Malaysian Communications and Multimedia Commission

Public Inquiry Report

Review of Access Pricing

16 February 2023

Figure 1: Modelled 5G data costs vs DNB's RAO (RM per Gbps)

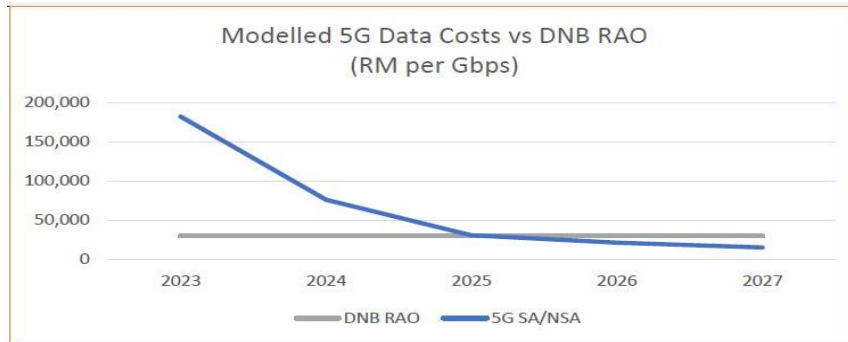
- 4.2.16 U Mobile further added that whilst this issue is less acute in situations where volumes are relatively stable and are large enough to enable network capacity to be adjusted to meet them, the 5G network faces just this issue. U Mobile noted that DNB has recognised this and set prices that are intended to reflect the lifecycle costs of its network. The MCMC however has applied a single-year methodology, tilted annuities, that yields uncompetitively high estimated costs in the early years, as shown in Figure 1.

4.2.17 U Mobile suggested the MCMC to either apply ED or adjust the modelled costs to avoid clear departure from the intended aim of replicating the behaviour of a reasonably efficient firm in an effectively competitive market.

Figure 2: How the Revised v6 Fixed Model deploys the Fibre Network

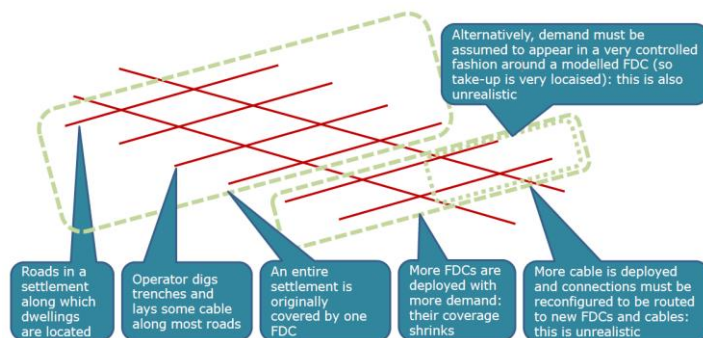
6.2.124 In reality, TM deploys FDCs in roadside cabinets which does not necessarily constitute the full capacity of the FDCs as it is depending on the density of the areas and availability of fibre routes connecting to distribution point serving the premises. TM provided its diagram on the deployment of the fibre network versus how the revised v6 fixed model is deploying the fibre network. Figure 2 shows how the revised v6 fixed model is deploying the fibre network.

6.2.125 TM submitted that the MCMC model should therefore better reflect the realities of fibre network deployment, with network build occurring more substantially ahead of demand. This could be accomplished by using a utilisation factor time series for FDC deployment, where the utilisation factor increases over time to the value assumed in the revised v6 fixed model. The factor value for 2022 can be derived by calibrating to TM’s actual FDC asset counts in 2022.

Figure 4: Breakdown of TM's Underestimate of Modelled Network Attributable OPEX in Fixed Model Version 6

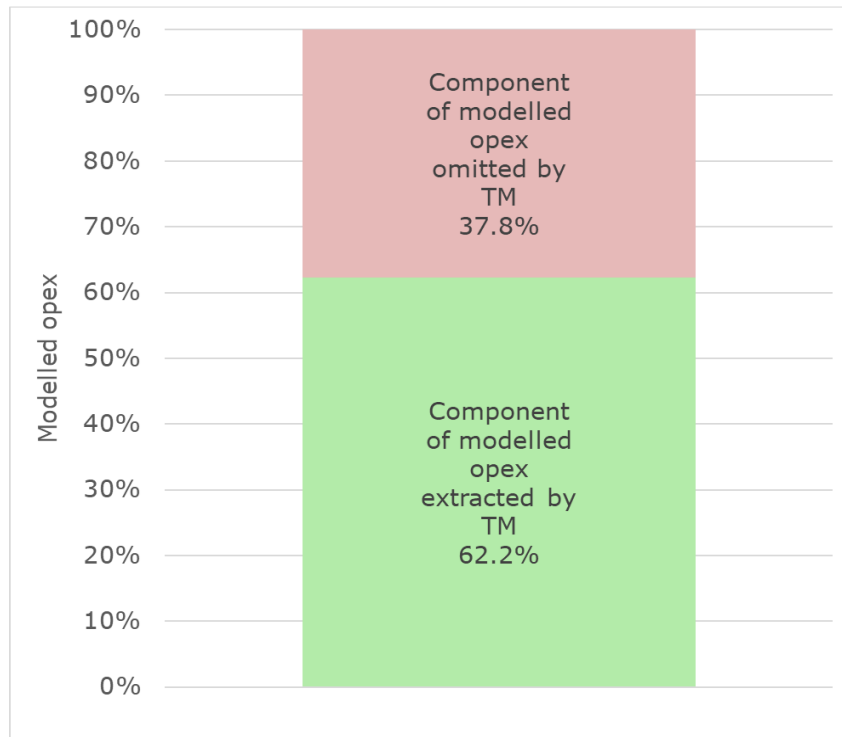
- 6.2.187 TM has assumed that the model applies the overhead mark-ups for common network costs and business overheads to direct OPEX. In fact, as the formula in the model shows, these mark-ups are applied to annualised costs – namely annualised CAPEX plus direct network OPEX. TM therefore grossly underestimated the mark-up calculated by the model by omitting a large component of these costs.

- 6.2.188 The outcome of TM's calculation error is that TM under-estimated the quantum of modelled network attributable OPEX in version 6 by 37.8 % and this is reflected in Figure 4.

6.2.189 The quantum of modelled network attributable OPEX increased in the final version of the model. The MCMC has compared the final modelled network attributable OPEX with TM's submitted value, and finds that over 69% of TM's submitted value has been included in the model.

Figure 6: End-to-End Transmission Service – High Level Network Diagram with SLAs

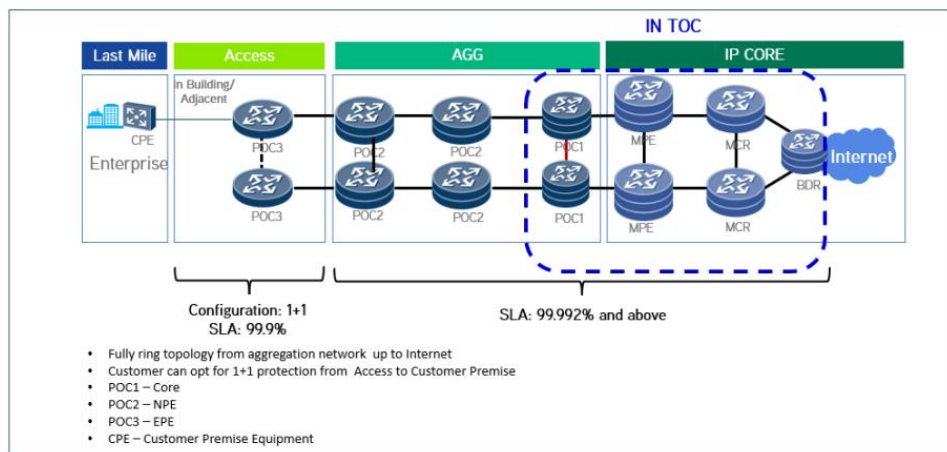
6.2.252 Maxis also proposed a high-level network diagram for End-to-End transmission as in Figure 6.

Figure 7: High-level Network Diagram for Layer 3 HSBB services

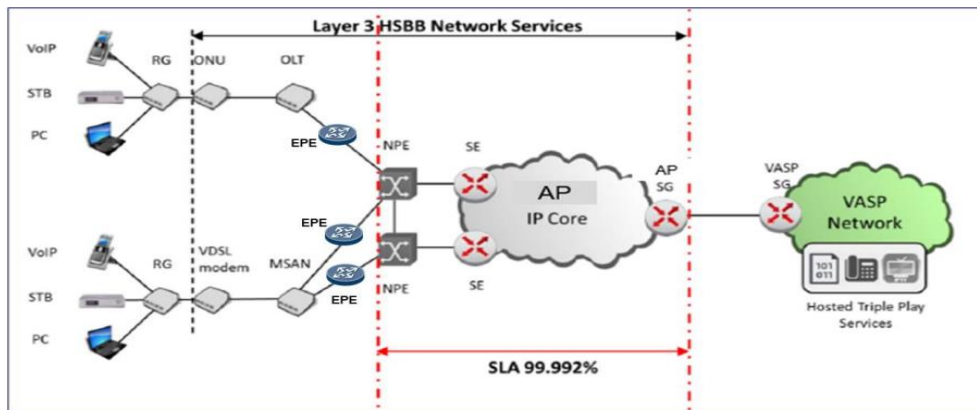
6.2.253 In addition, Maxis proposed to include 99.992% SLA for core network (SG → NPE) for the regulated prices to avoid the disputes between AP and AS, for Layer-3 HSBB Network Services. The high-level network diagram is shown in Figure 7 below:
